UNITED STATES PATENT AND TRADEMARK OFFICE

APPLICATION NO.	FILING DATE	FIRST NAMED INVENTOR	ATTORNEY DOCKET NO.	CONFIRMATION NO.
10/726,464	12/03/2003	James P. Beckham	297912006402	5880
25224	7590	06/06/2005		
MORRISON & FOERSTER, LLP 555 WEST FIFTH STREET SUITE 3500 LOS ANGELES, CA 90013-1024			EXAMINER THOMPSON, MICHAEL M	
			ART UNIT 3763	PAPER NUMBER

Office Action Summary

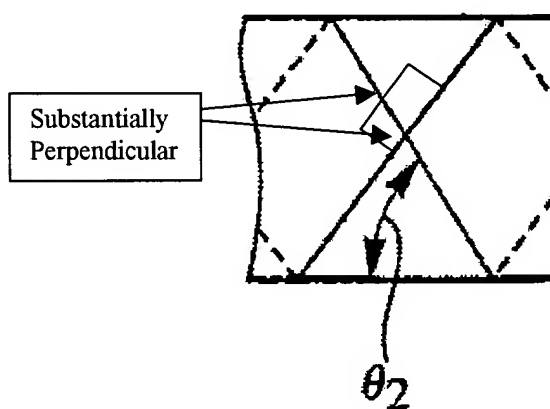
Furthermore, with respect to Applicant's fiber layer materials it is the Examiner's position that Jorgenson teaches polyethylene that meets Applicant's description of inelastic fibers. As shown below it is also the Examiner's position that the fiber layers are "substantially" at a right angle and they are "about" at an angle of 10 degrees.

In addressing the first fibers being equal in length to the long axis of the balloon, the Examiner submits that even though the fibers are helically wound, they are substantially the length of the long axis in that they do not appear to extend past the ends of the balloon section and run substantially the longitudinal length albeit in a helical fashion.
